SECTION III STANDARD DRAWINGS

ROYSE CITY GENERAL CONSTRUCTION NOTES & DETAILS

City of Royse City Special Provisions to Section II
Standard Drawings of the Standard Specifications for Public Works Constructing
North Central Texas, 4th Edition, dated October 2004
(City's Revisions - March 2012)

Standard Drawing No. 6030C (Curb Inlet Recessed — Inlet Throat and M.H. Frame and Cover). Drawing shall be modified as follows:

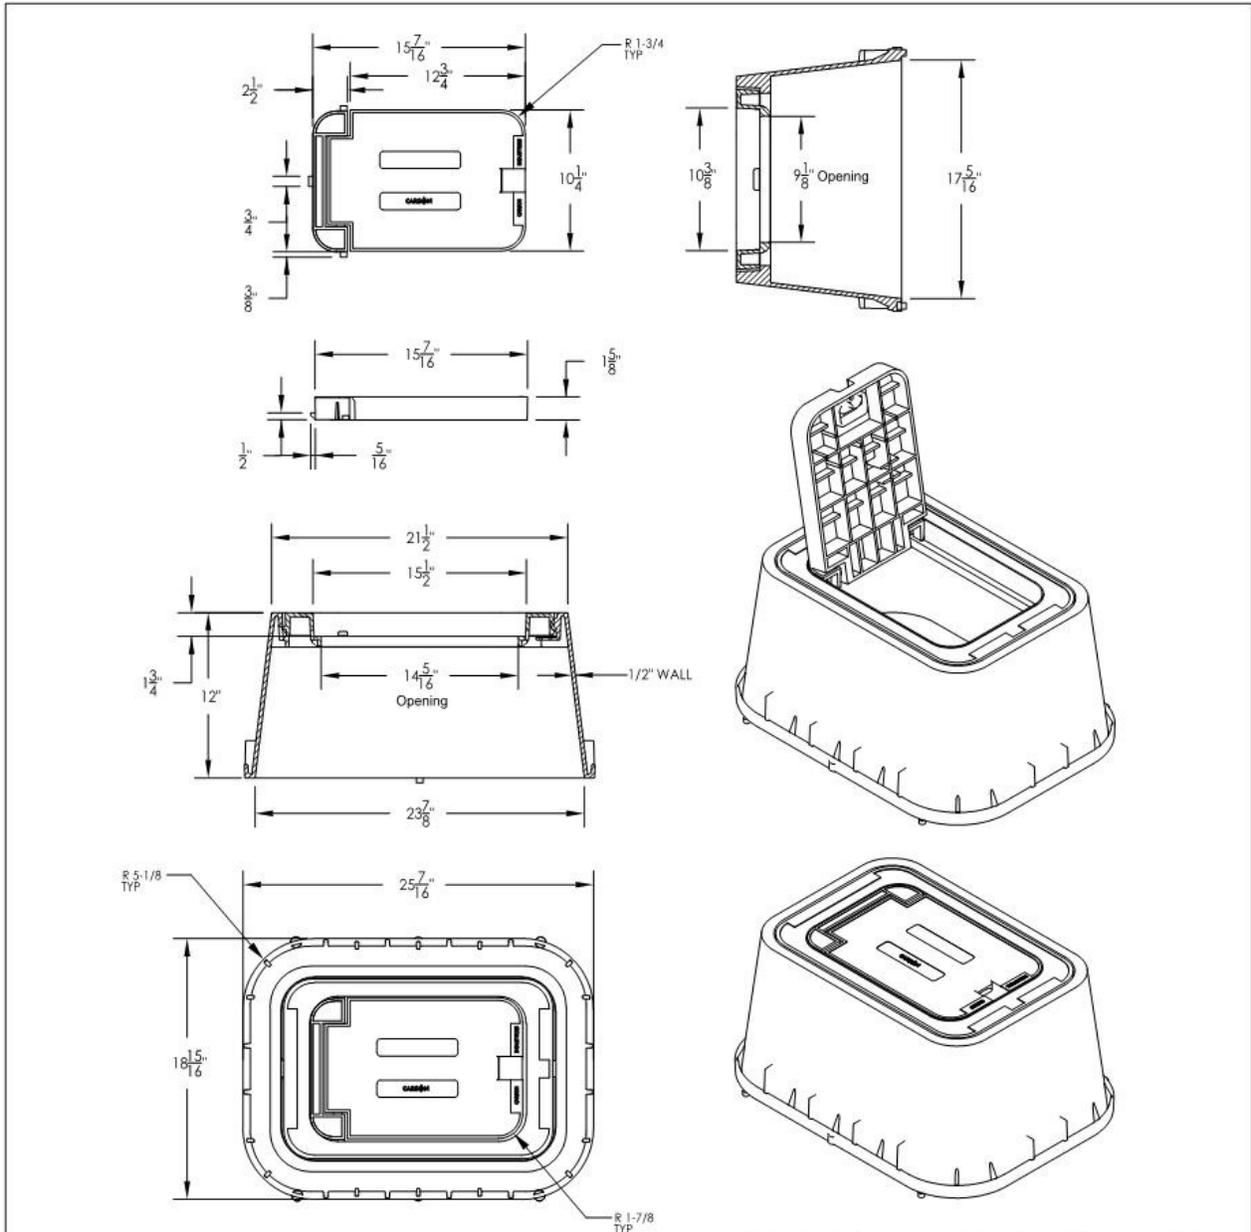
1. Recessed inlet back of curb distance to be three (3) feet from street back of curb (not two (2) feet).
2. Gutter depression to be six (6) inches.
3. Inlet lid to be locking.

WASTEWATER LATERAL CONNECTIONS

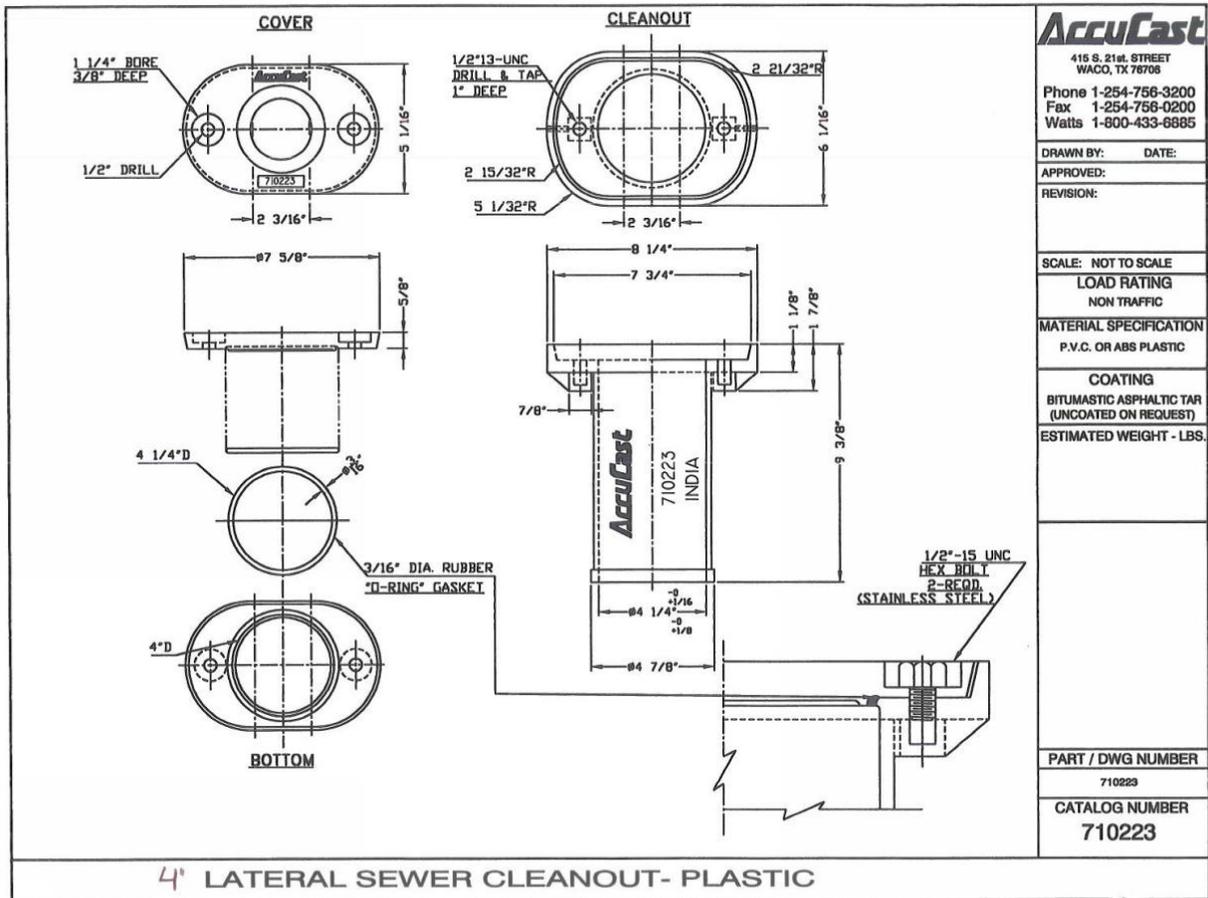
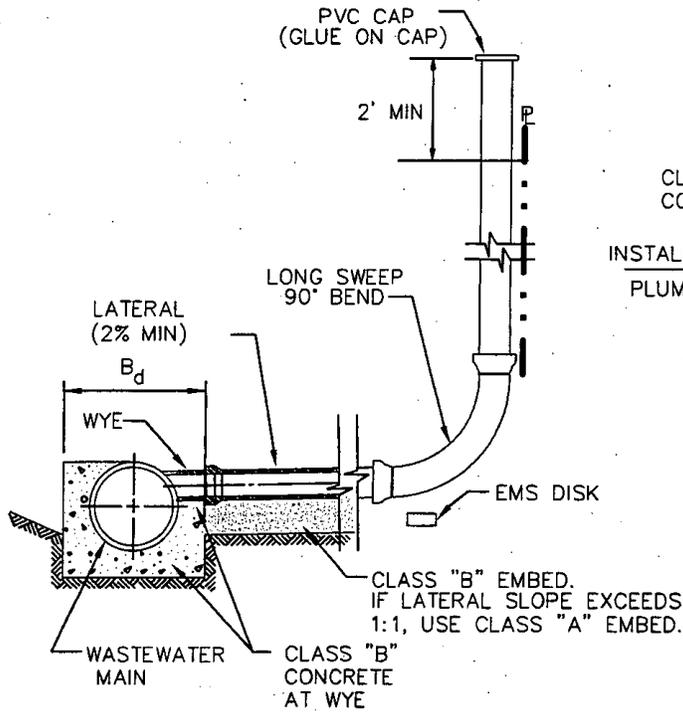
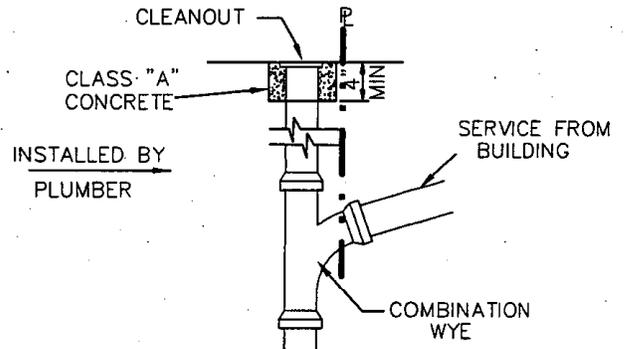
1. Replace with City Detail.
2. Green EMS disk shall be installed at cleanout or end of lateral.
3. Cleanout shall be cast iron sewer cleanout, Type Trinity Valley, Pattern 1684 or approved equal.
4. If cleanout is installed in roadway or parking area then traffic cleanout shall be designed to handle traffic loads.
